Subdivision Authority

File No. LDA11-0407

RE: Tentative plan of subdivision to create one (1) medium density residential lot and, one (1) Public Utility Lot, from portions of the West Half of N1/2 15-51-24-4 and Lot A, Plan 3422TR; **THE ORCHARDS AT ELLERSLIE**

SUBDIVISION CONDITIONS OF APPROVAL MAP

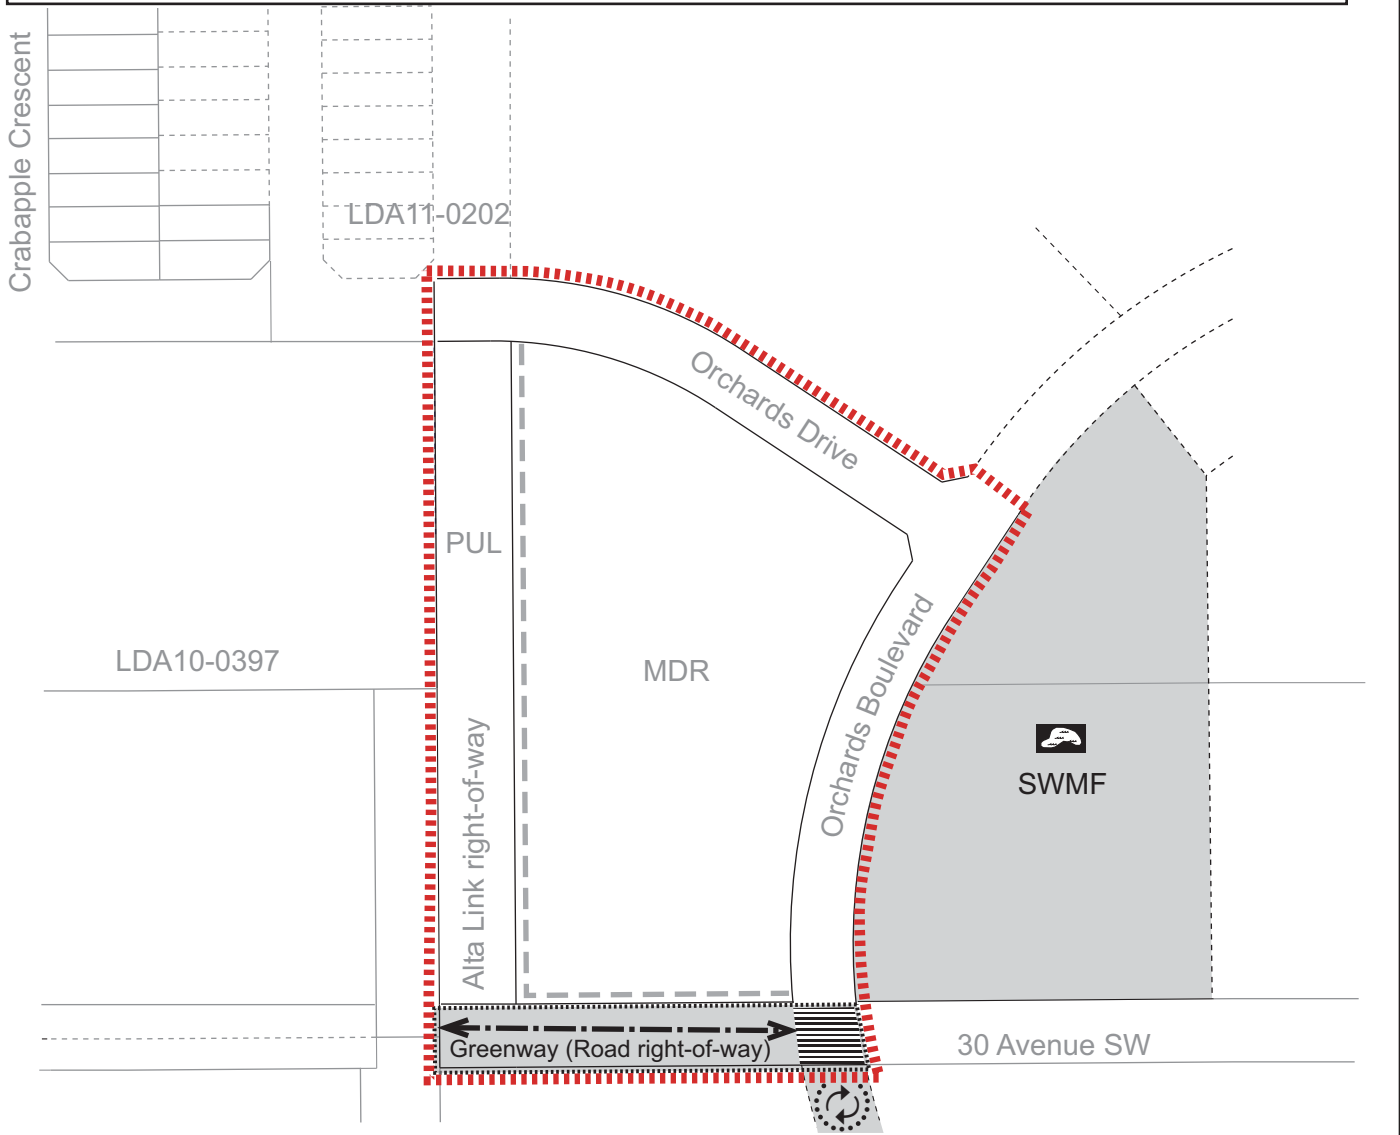
3. that the owner enter into a Servicing Agreement with the City of Edmonton pursuant to Section 655 of the Municipal Government Act;
4. that the subdivision boundary be amended to exclude 30 Avenue SW, as shown on the "Conditions of Approval" map, Enclosure I;

7. that the engineering drawings include the ultimate design and interim construction of the stormwater management facility, to the satisfaction of Infrastructure Services, as shown on the "Conditions of Approval" map, Enclosure I;

8. that the engineering drawings include the construction of an offset 17 m radius asphalt surface temporary transit turnaround with bollards or mini-barriers, as shown on the "Conditions of Approval" map, Enclosure I. A gravel turnaround will be required prior to CCC and an asphalt turnaround will be required prior to FAC, or earlier at the discretion and direction of Transportation Services;

9. that the engineering drawings include construction of a 3 m hard-surface shared use path, with a dividing yellow centerline, "Shared Use" signage, lighting, bollards and landscaping, as shown on the "Conditions of Approval" map, Enclosure I;

10. that the engineering drawings include a zebra marked crosswalk with curb ramps, curb extensions and pedestrian signage at the mid-block crossing, as shown on the "Conditions of Approval" map, Enclosure I;

11. that the owner construct all fences wholly within private lands, bollards, lighting, shared use paths, and sidewalks, to the satisfaction of the Transportation Services and Sustainable Development in the locations identified on the "Conditions of Approval Map", Enclosure I; and
